<b>PCN Date:</b> 10May10		<b>Effective Date:</b> 10May10	
<b>Title:</b> EMS TQFP MSL Reclassification - 250 °C to 260 °C			
<b>Originator:</b> Yi Yin Chee	<b>Phone:</b> +65 - 6511 7749	<b>Dept:</b> Supplier Quality	
<b>Customer Contact:</b> Kathy Haggar	<b>Phone:</b> +1.512.532.5261	<b>Dept:</b> Inside Sales	
<b>PCN Type:</b>			
<input type="checkbox"/> Assembly	<input type="checkbox"/> Discontinuance	<input checked="" type="checkbox"/> Package	<input type="checkbox"/> Test
<input type="checkbox"/> Datasheet	<input type="checkbox"/> Fabrication	<input type="checkbox"/> Product Revision	
<input type="checkbox"/> Packing	<input type="checkbox"/> Labeling	<input type="checkbox"/> Location	<input type="checkbox"/> Other
<b>Last Order Date:</b> 10May10			
<b>PCN Details</b>			
<b>Description of Change:</b>			
<p>Silicon Labs is pleased to announce the successful MSL reclassification of the 64-TQFP-10X10 and 100-TQFP-14X14 devices in accordance with JEDEC JSTD020. The reclassification qualification increases the allowable maximum reflow temperature from 250 °C to 260 °C. The reclassification ensures our products will meet peak temperature expectations of lead free reflow profiles per JED

Old - MSL 250 °C Label

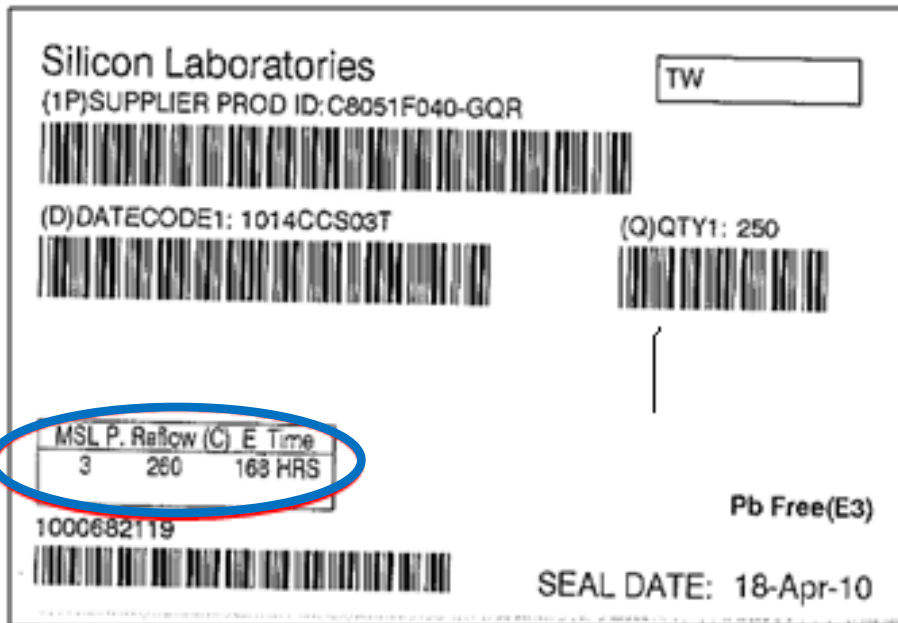
Maximum reflow temperature labels will reflect 260 °C instead of 250 °C, see examples below:
